Project	IEEE 802.16 Broadband Wireless Access Working Group < http://ieee802.org/16 >	
Title	Changes on Sleep Mode SDLs and MSCs	
Date Submitted	2004-01-15	
Source(s)	Chulsik Yoon, Jaeheung Kim, Kunmin Yeo ETRI 161 Gajeong-Dong, Yuseong-Gu, Daejeon, Korea	Voice: +82-42-860-6826 Fax: +82-42-860-6732 mailto: csyoon@etri.re.kr
Re:	This is a response to a Call for Comments IEEE 802.16e-03/58 on IEEE 802.16e-03/07r5	
Abstract	This document contains suggestions to change the SDLs and MSCs reflecting working groups agreements on the Sleep Mode operation.	
Purpose	The document is submitted for review by 802.16e Working Group members.	
Notice	This document has been prepared to assist IEEE 802.16. It is offered as a basis for discussion and is not binding on the contributing individual(s) or organization(s). The material in this document is subject to change in form and content after further study. The contributor(s) reserve(s) the right to add, amend or withdraw material contained herein.

Changes on Sleep Mode SDLs and MSCs

2. Proposed changes on Sleep Mode operation SDLs and MSCs in IEEE 802.16e-03/07r5

Figure 108n – BS-SS Sleep Mode SDL Diagram

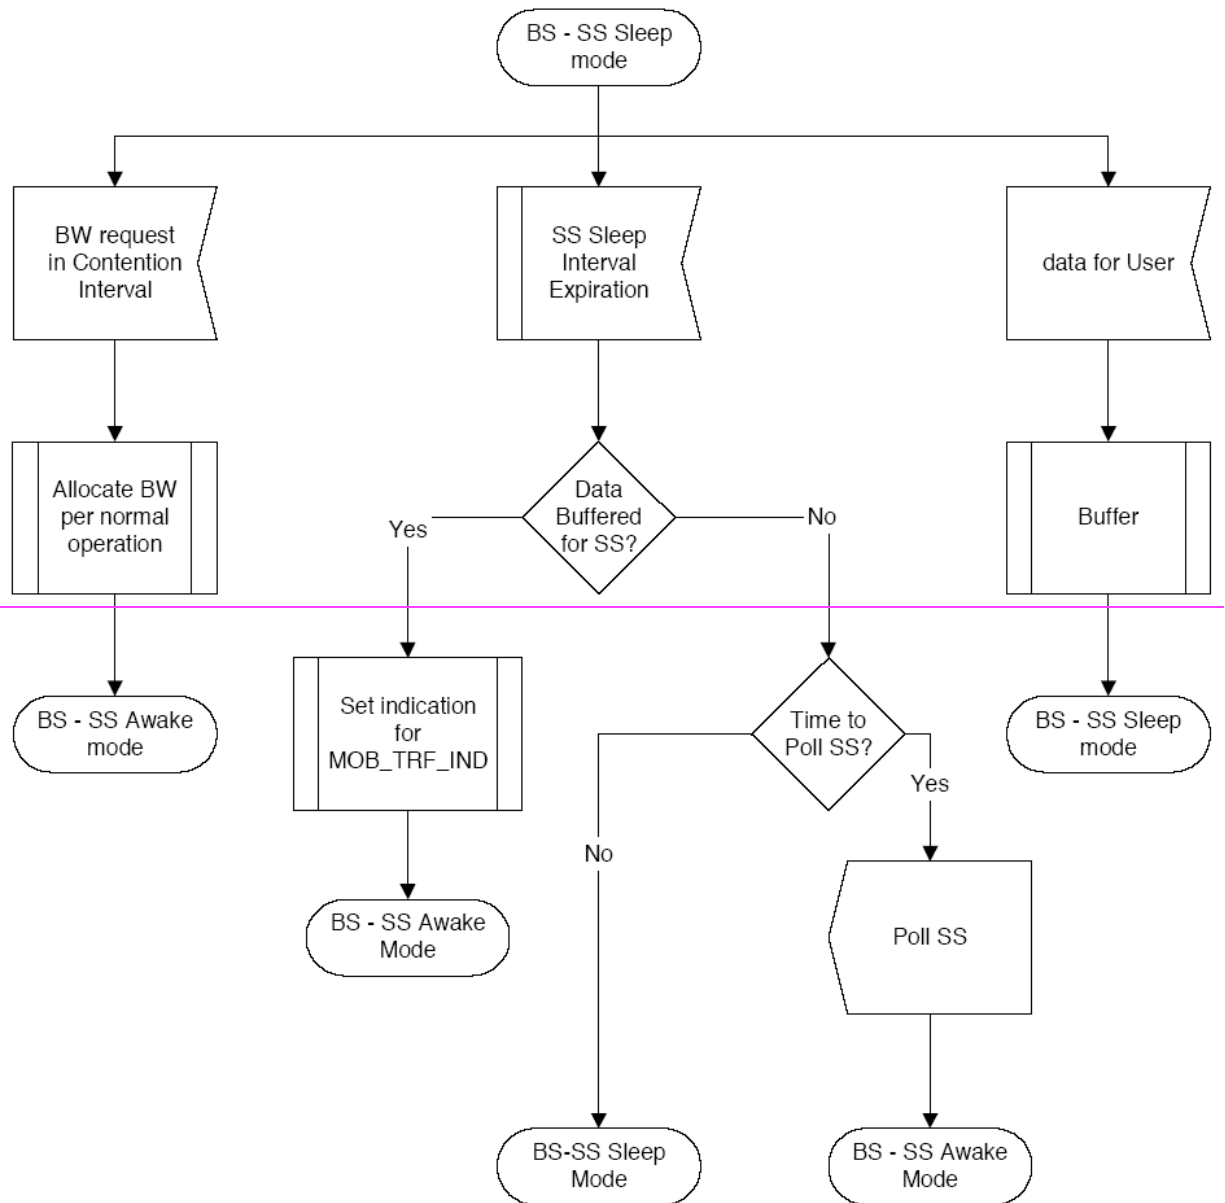
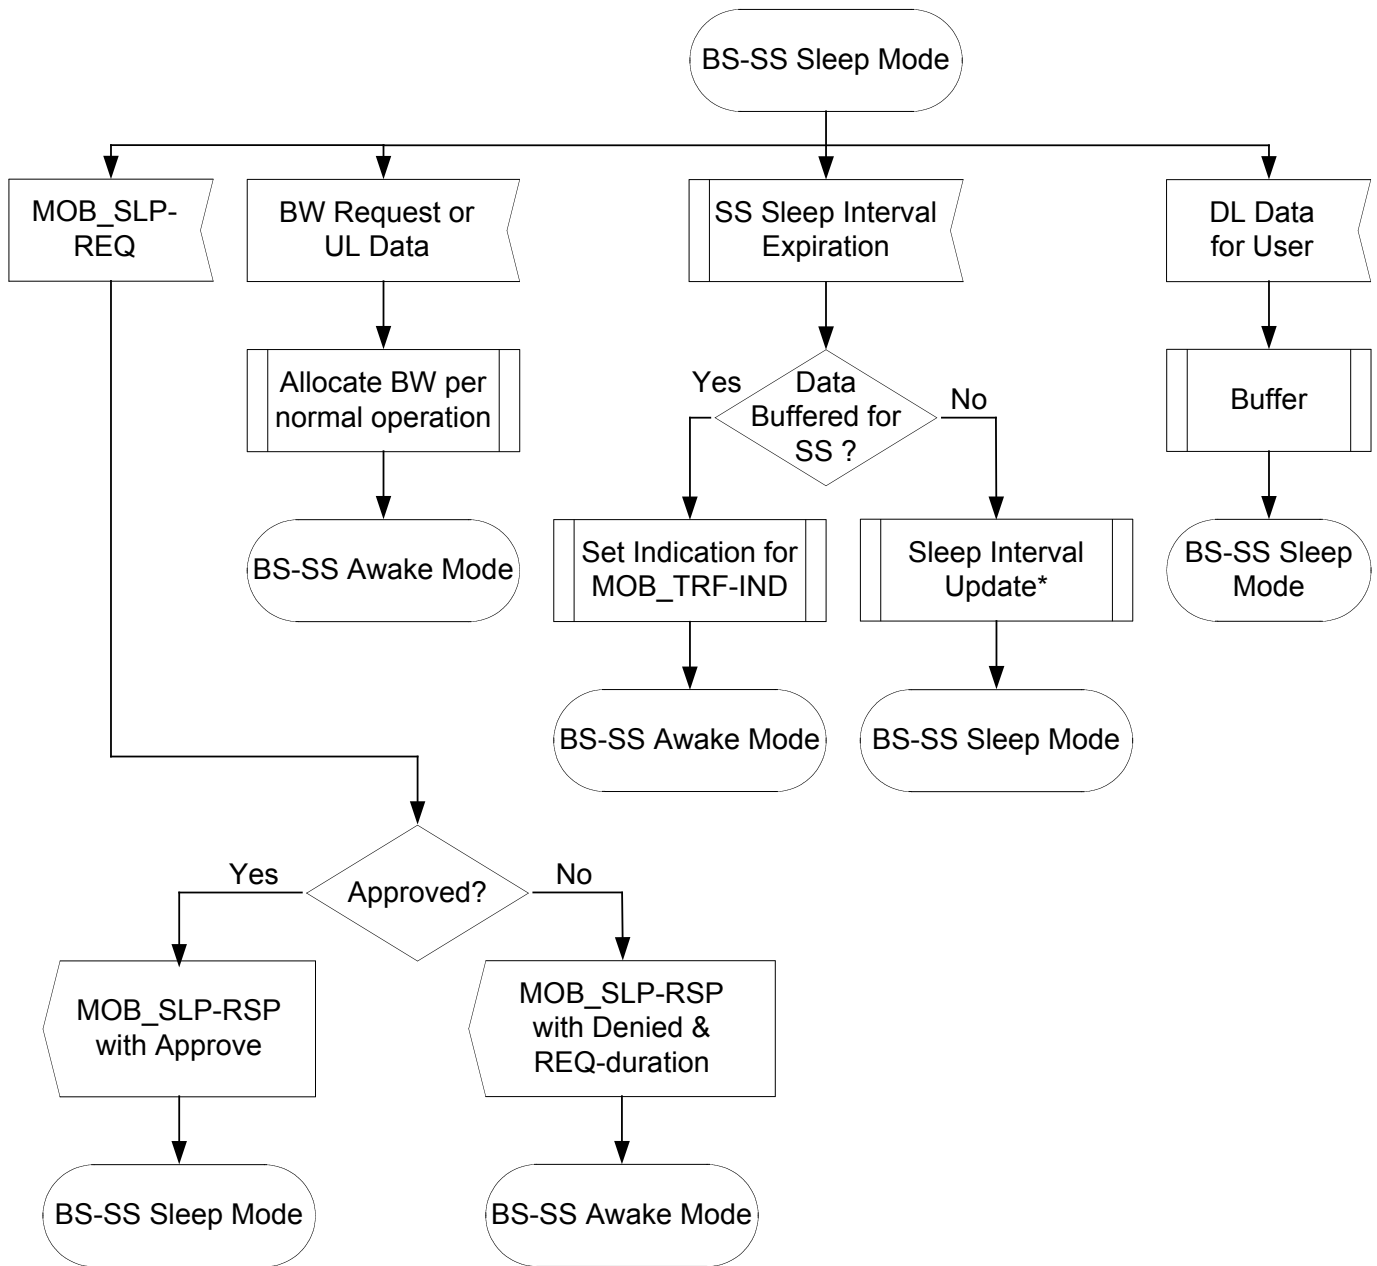
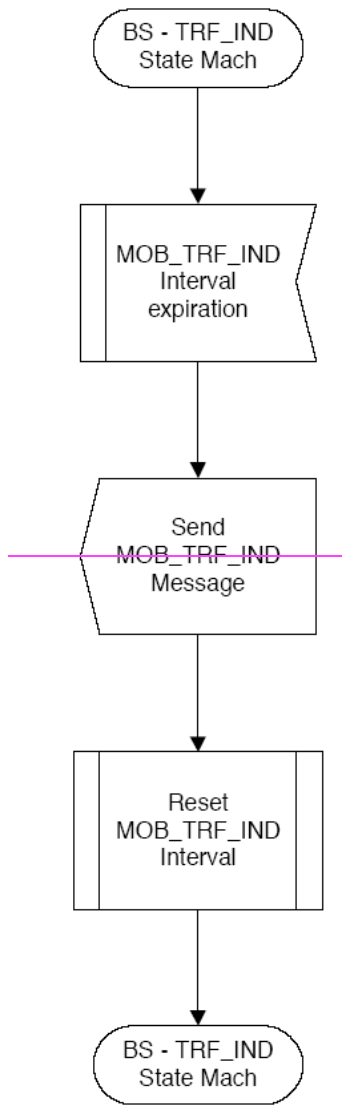
[Replace Figure 108n to the following:]
[From:]

Figure D.11 – Sleep Mode – MSS initiated

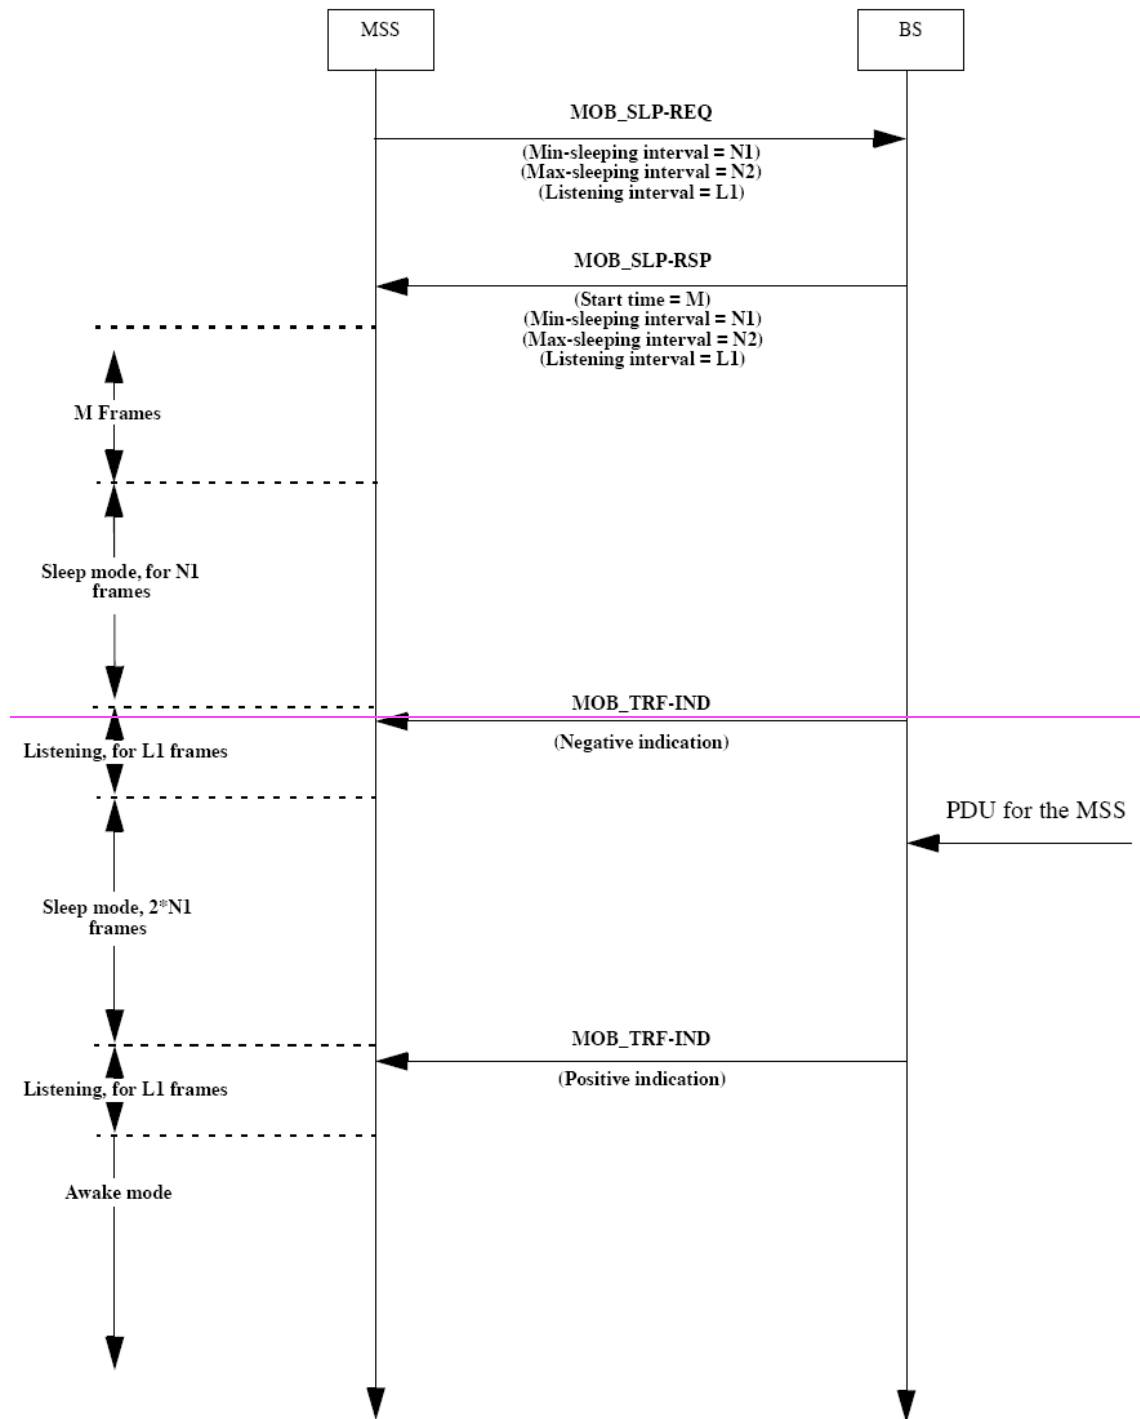
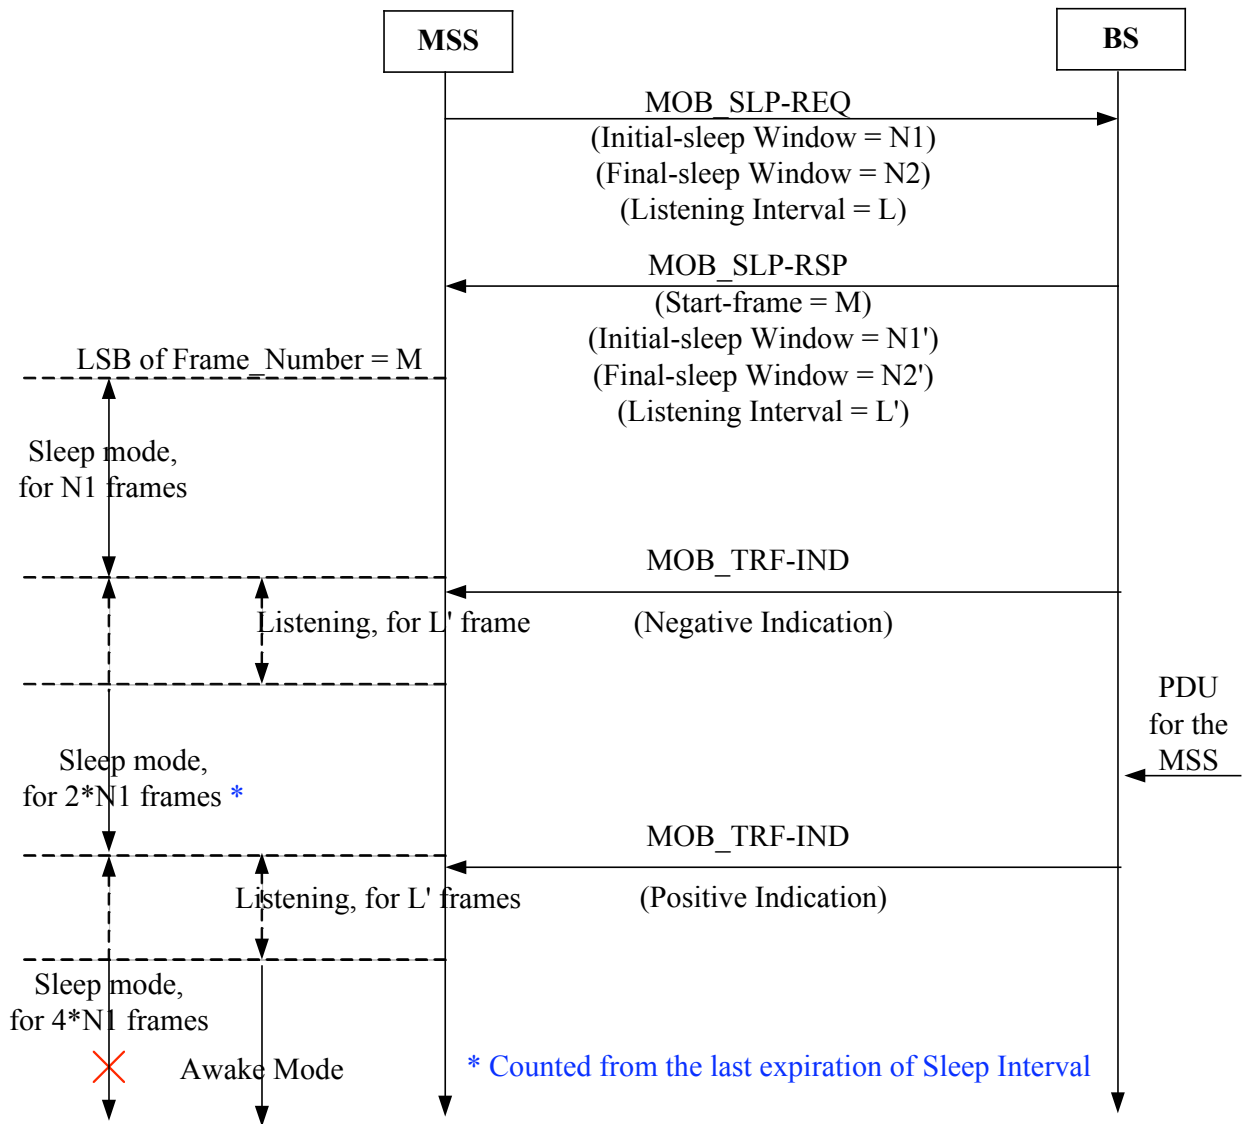
[Replace Annex D.2 Figure D.11 to the following:]
 [From:]

Figure D.12 – Sleep Mode – BS initiated

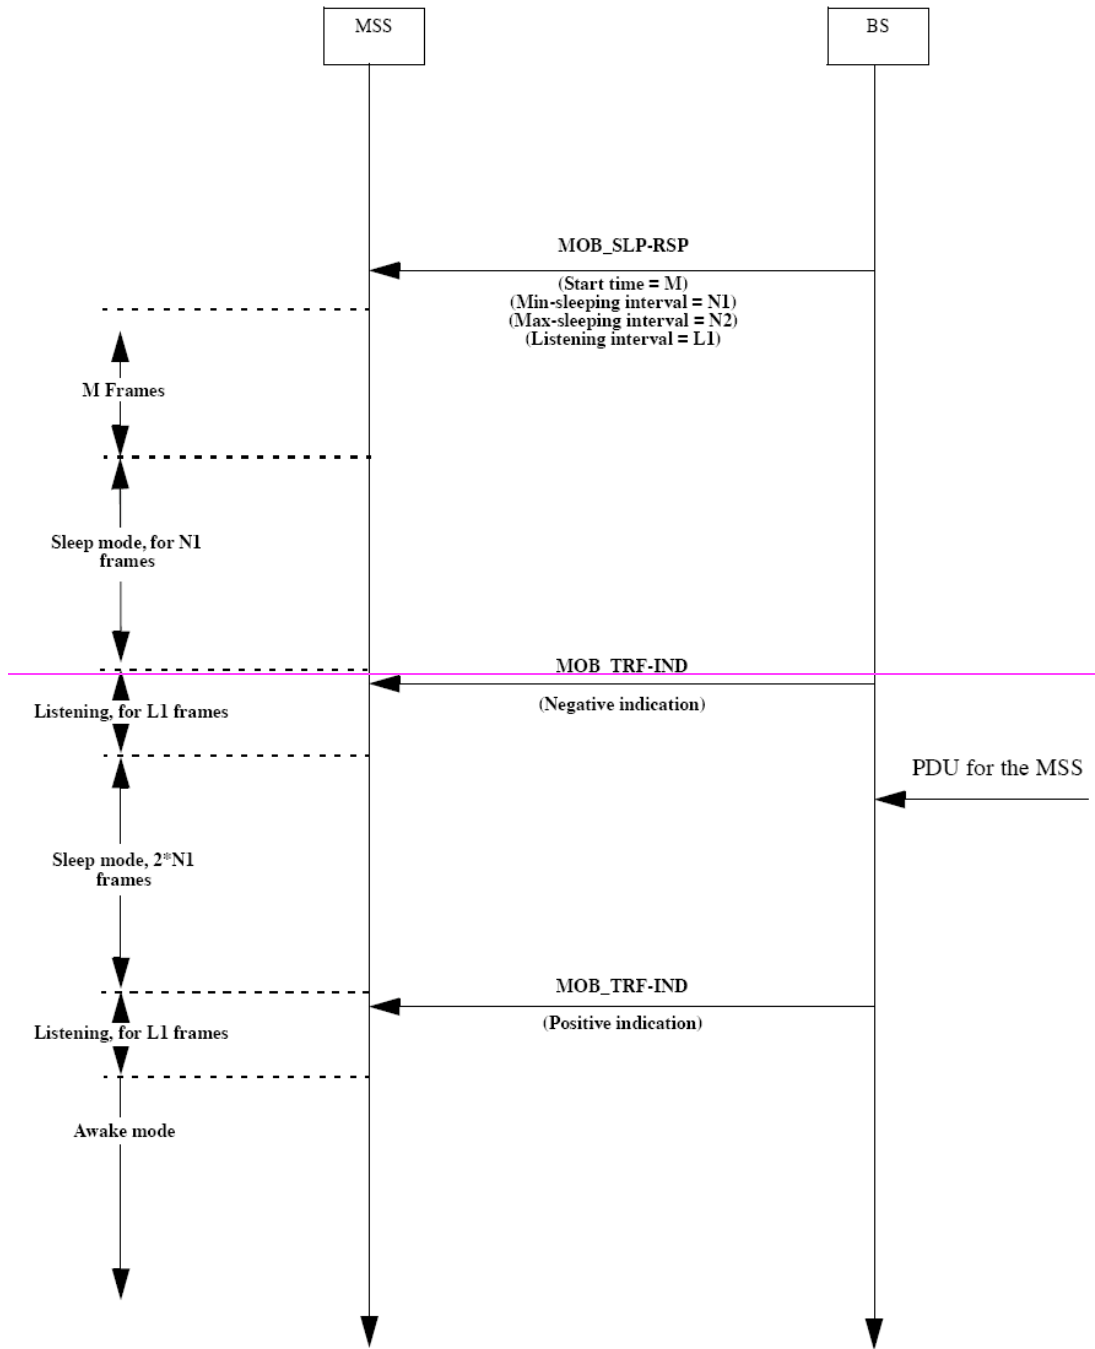
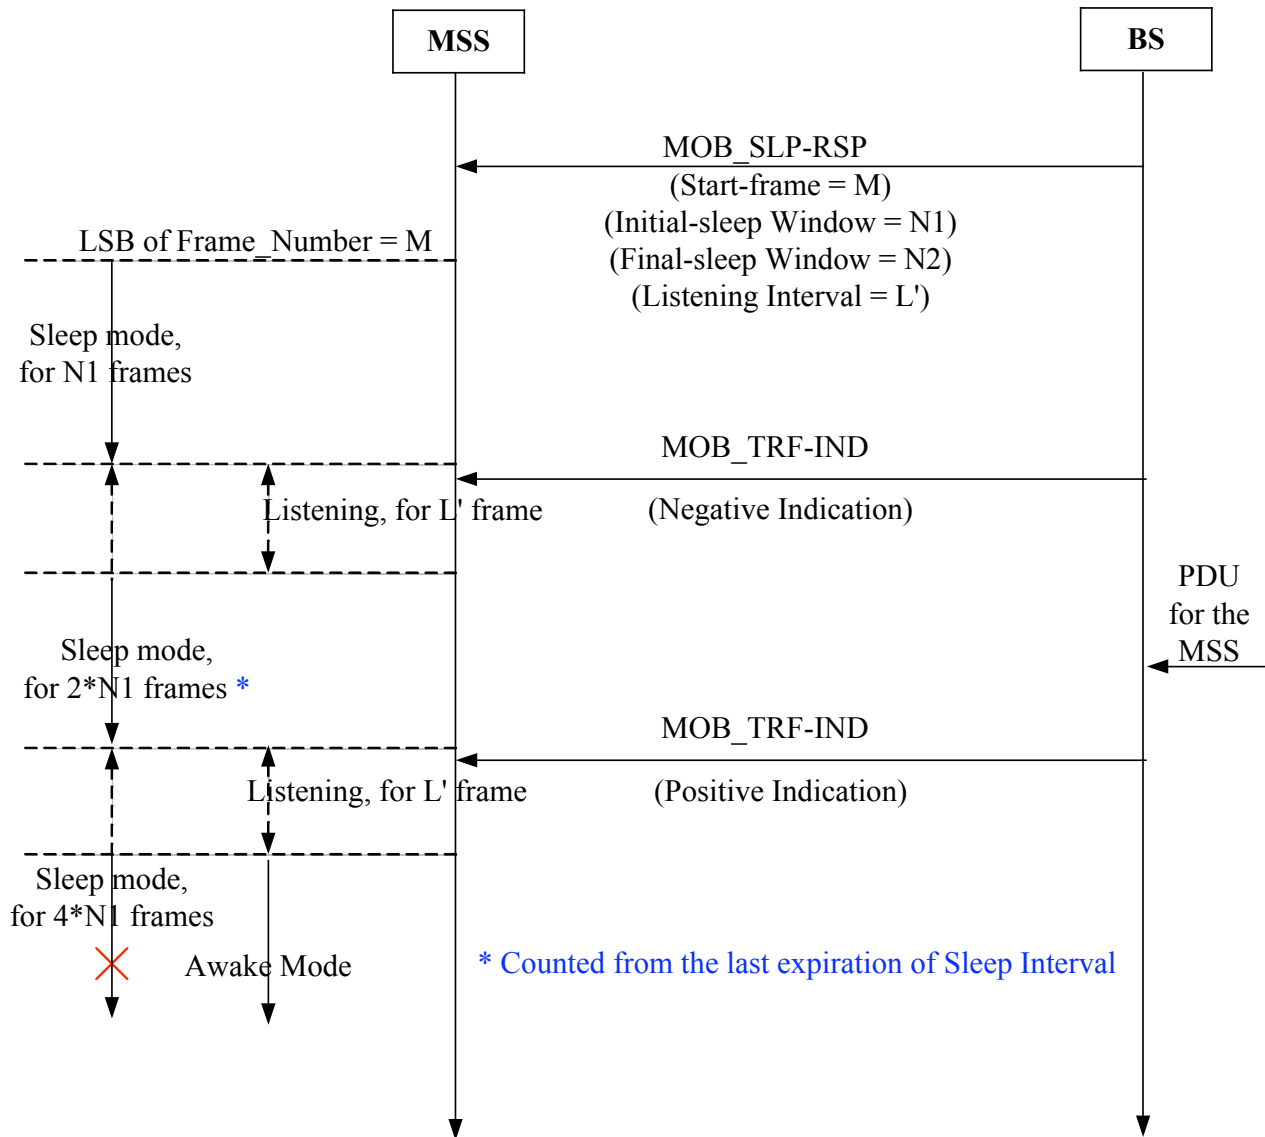
[Replace Annex D.2 Figure D.12 to the following:]
[From:]
